DEVELOPMENT REVIEW BOARD  
SUPPLEMENTAL SUBMITTAL

PROJECT NO. PR-2021-006070  
Application No. SI-2021-01888

**Re:** Westpointe40 South Site Plan DRB Comment Responses (PR-2021-006070)

This memo outlines the responses and changes made to the site plan for the proposed 60K warehousing and distribution building at Westpointe40 based on the comments received and reviewed at the December 1, 2021 DRB meeting. The comments are numbered and followed by the response in italics.

EXTERIOR BUILDING ELEVATIONS

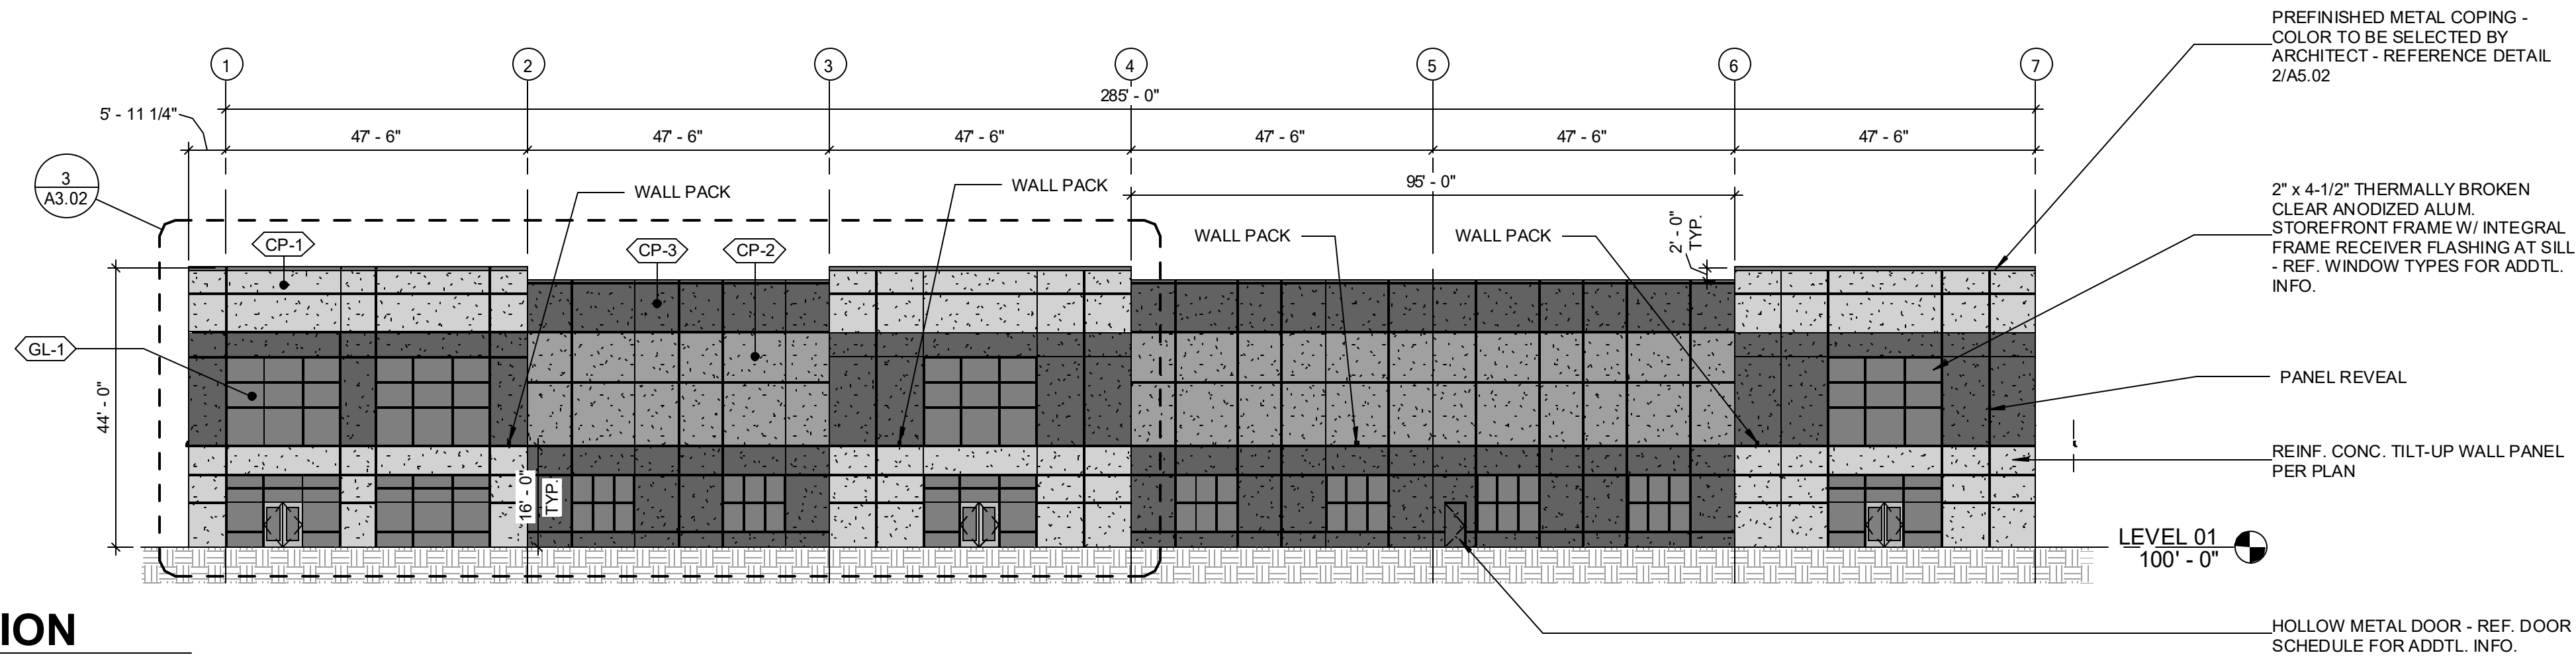
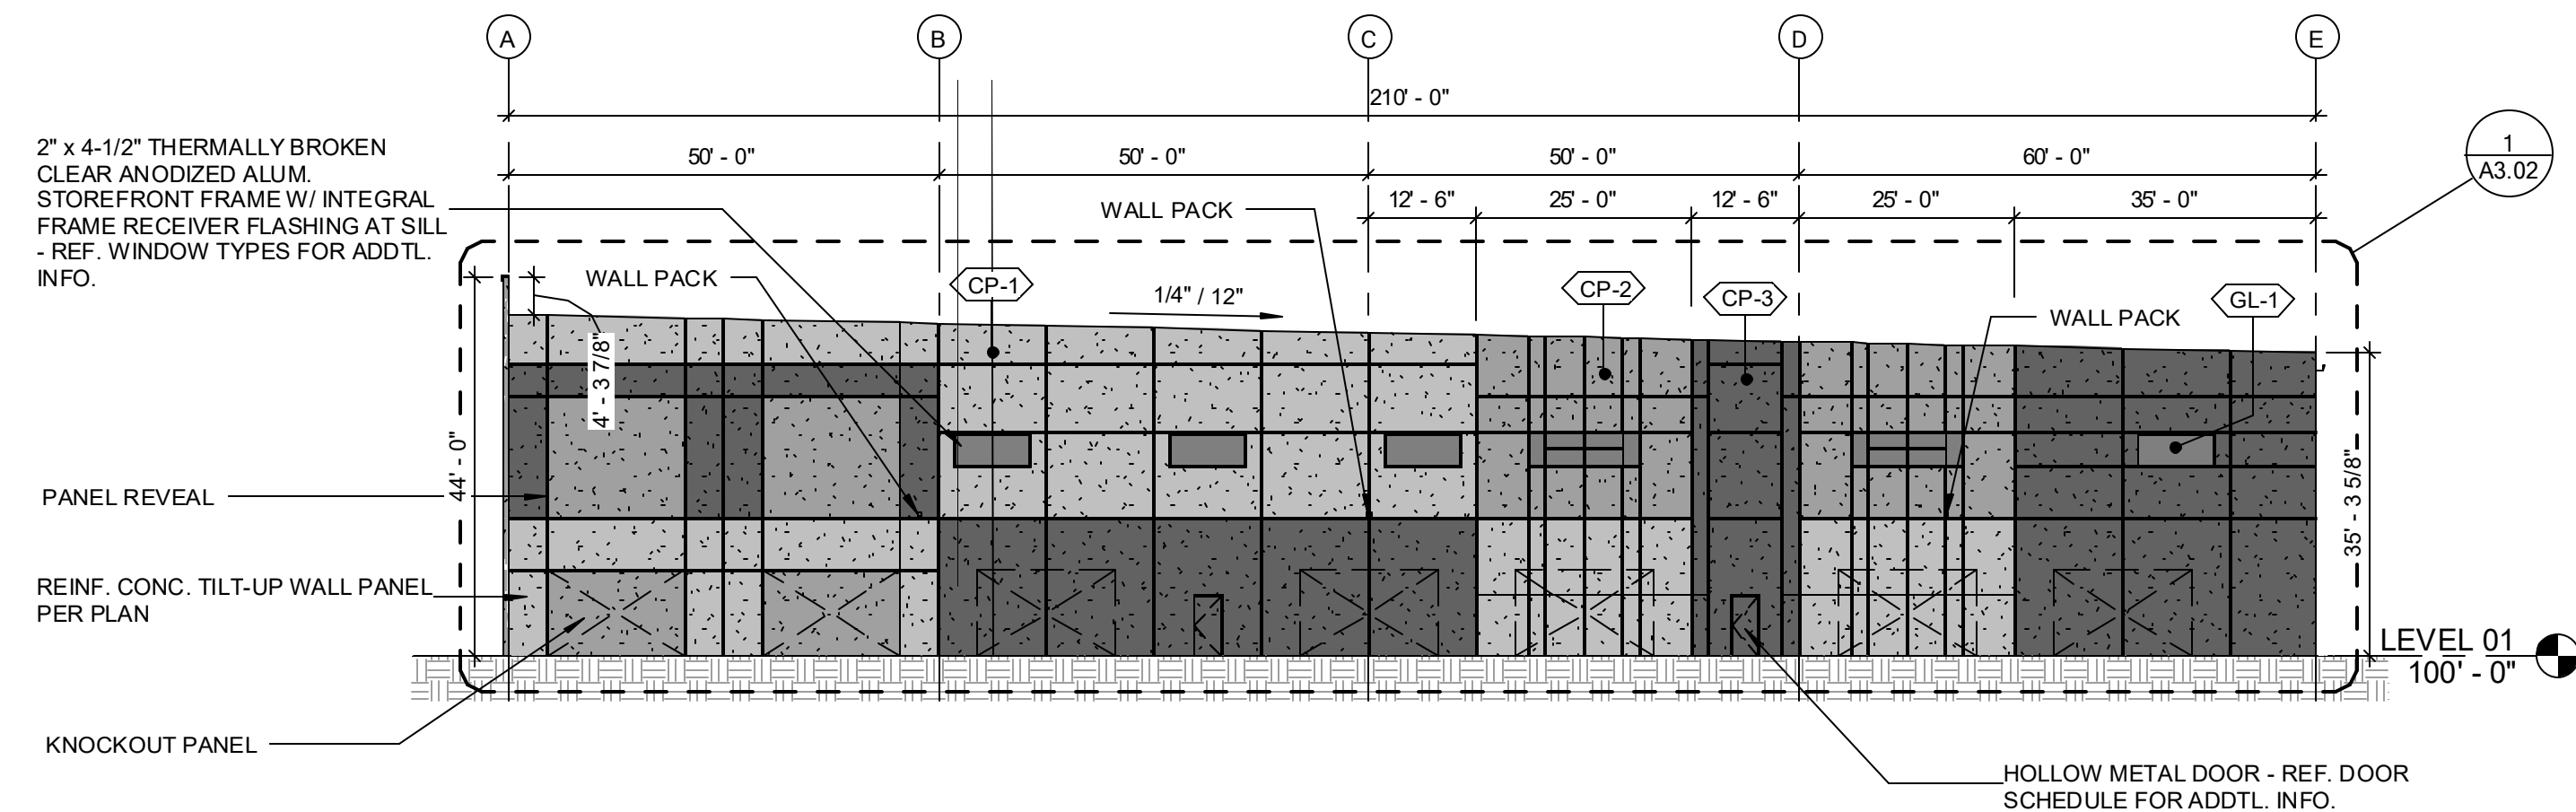
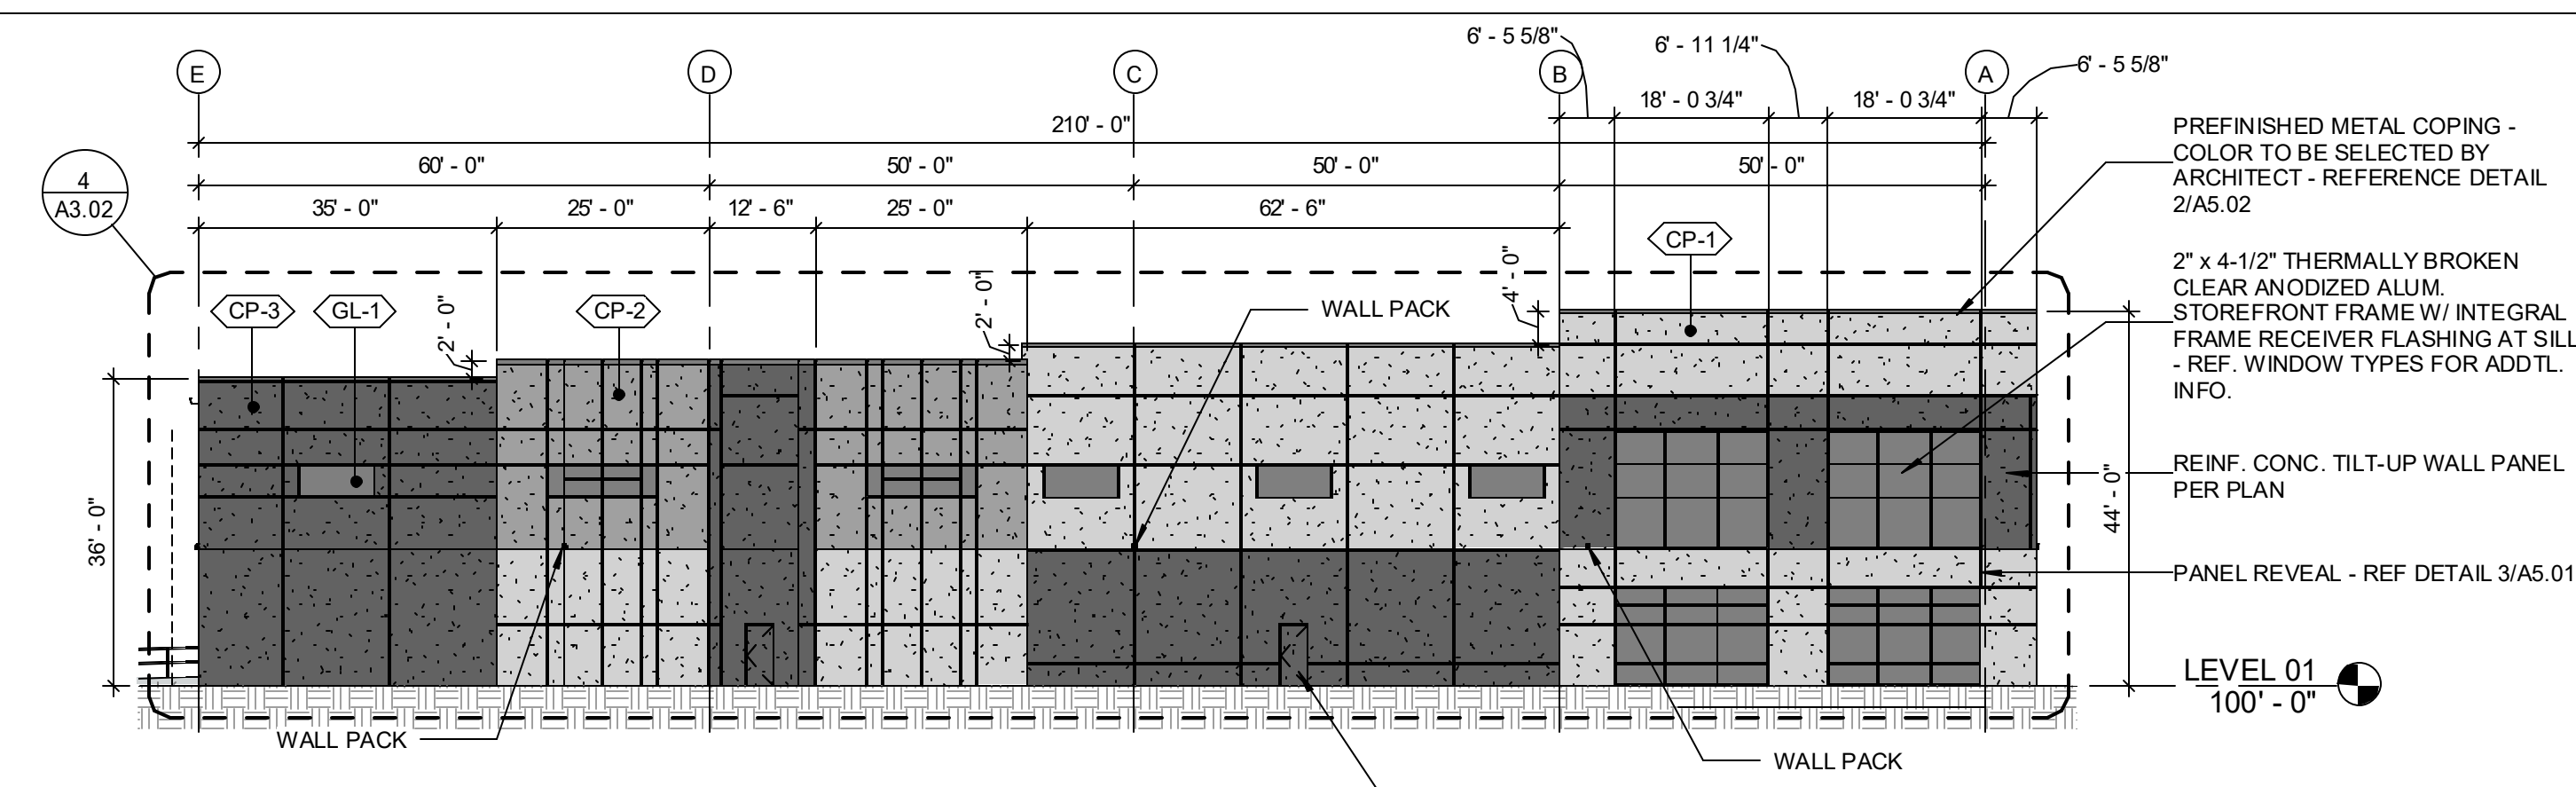
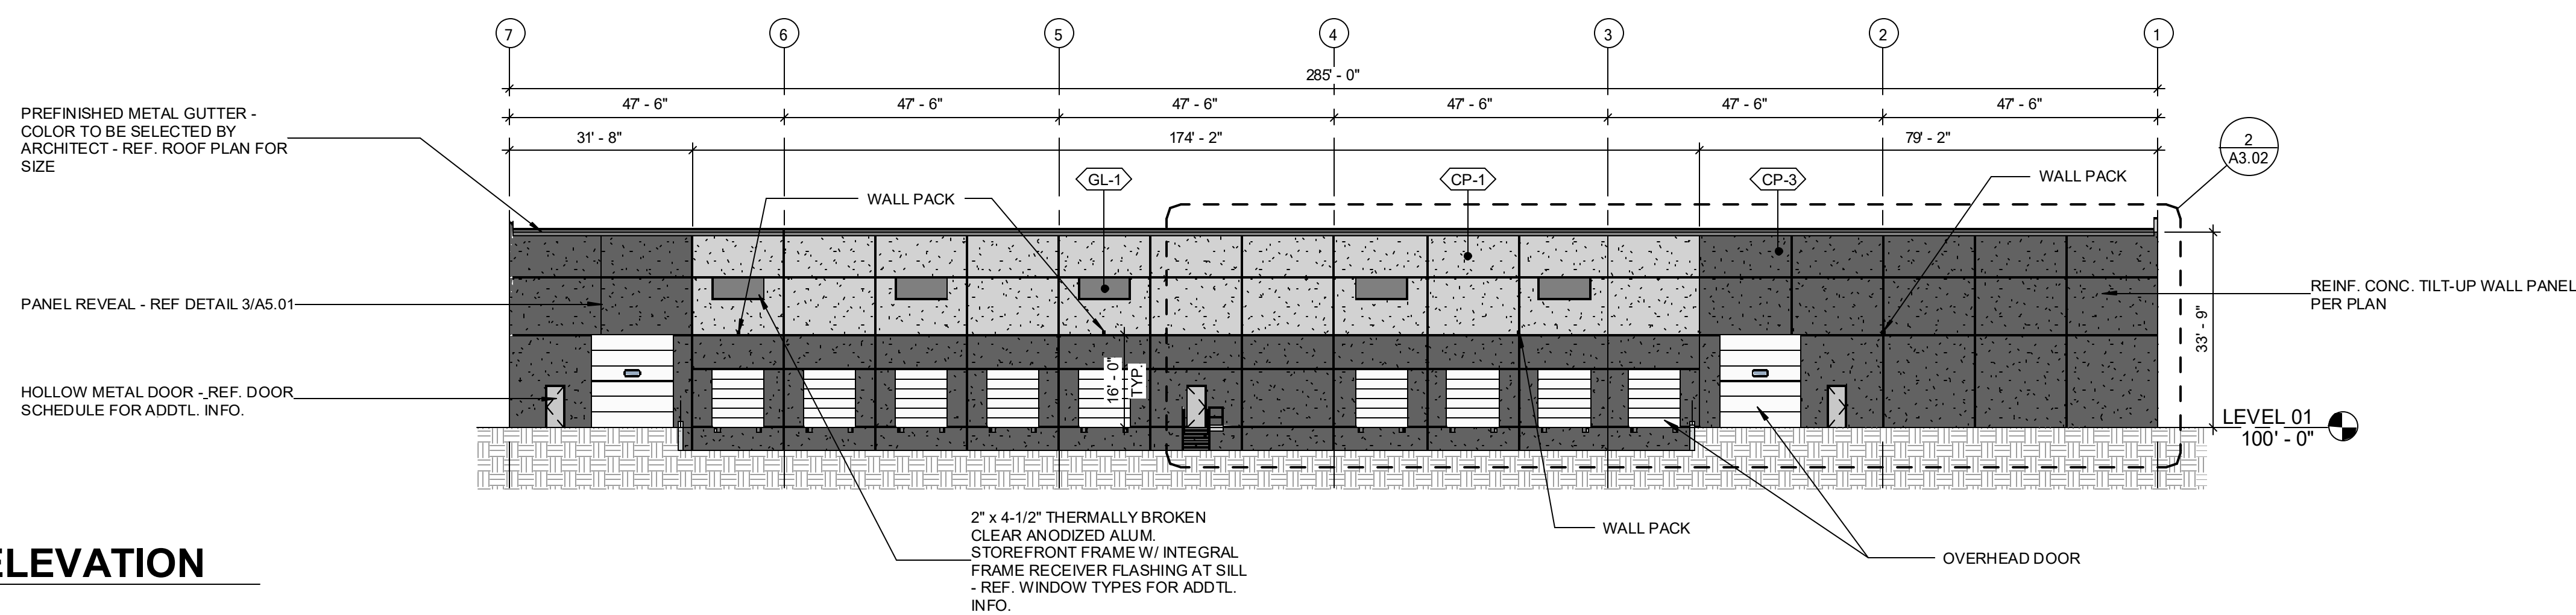
8. Additional detail needed for meeting Façade Design general standards, IDO section 5-11-E.
  - *Despite the large size and function of the building, a human scale is provided along the primary building façade through a differentiation in colors and use of windows and doors around entries.*

- *The building is setback more than 30 feet from Bluewater Road, so it does not meet the definition of a street-facing façade and therefore is not required to meet the standards outline in Section 5-11(E)(2)(a)2. However, the applicant has taken care to provide visible primary pedestrian entrances and the use of ground floor windows to improve the overall look and feel of the building from the parking lot.*

- *While it is not considered a street-facing façade, the south elevation breaks up its length using a change in parapet heights and building articulation every 50 feet, as well as using multiple colors along the entire length of the façade.*
